HISTORIC AND DESIGN REVIEW COMMISSION November 15, 2017

HDRC CASE NO:	2017-550
ADDRESS:	213 SWEET
LEGAL DESCRIPTION:	NCB 2558 BLK E LOT 12
ZONING:	RM-4, H
CITY COUNCIL DIST.:	1
DISTRICT:	Nathan Historic District
APPLICANT:	Sylvia Trevino
OWNER:	Cristela Canales
TYPE OF WORK:	Construction of a rear addition
APPLICATION RECEIVED:	October 27, 2017
60-DAY REVIEW:	December 26, 2017

The applicant is requesting conceptual approval to:

- 1. Construct a two story, rear addition to the historic structure located at 213 Sweet Street in the Nathan Historic District.
- 2. Demolish an existing, rear accessory structure.

PERSPECTIVE - LOOKING EAST

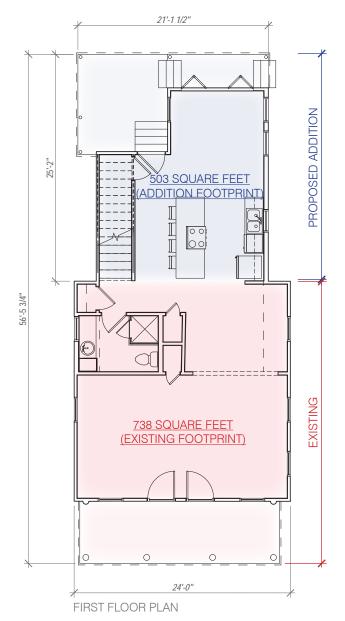
- f. SCALE, MASS & FORM Regarding scale, mass and form, the applicant has proposed an addition that features a footprint that is 68 percent of the footprint of the historic structure and features two stories whereas the historic structure only features one. While the proposed footprint and height are not consistent with the Guidelines, staff finds that application documents provided by the applicant such as perspectives note that the proposed addition will not necessarily overwhelm the historic structure. Staff finds that the separation between the two structures should be increased to further reduce the perceived massing of the addition if a complete separation was proposed between the second story of the addition and the rear slope of the historic side gable. The roof structure that connects to the rear slope of the historic structure's side gable should be reduced in height to be subordinate to the height of the historic structure's ridge line and the east wall of the proposed second story should start clear of the rear of the historic, side facing gable.

- i. That the separation between the proposed addition and historic structure be increased to further reduce the perceived massing of the addition through a complete separation between the second story of the addition and the rear slope of the historic roof. The roof ridge height of the new structure that connects to the rear slope of the historic roof to the addition should be reduced to be subordinate to the historic structure's ridge line. The east wall of the proposed second story should not interrupt the roof line of the historic structure.

ROOF PLAN

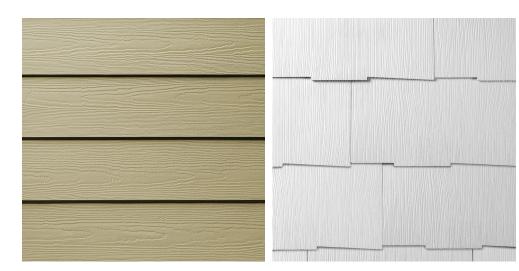
- d. ROOF FORM The applicant has proposed a hipped roof facing Sweet Street, complementary of that of the historic structure's porch and a rear gabled roof facing the rear alley. Staff finds the overall proportion and form of both roof forms to be architecturally appropriate and consistent with the Guidelines 1.A.
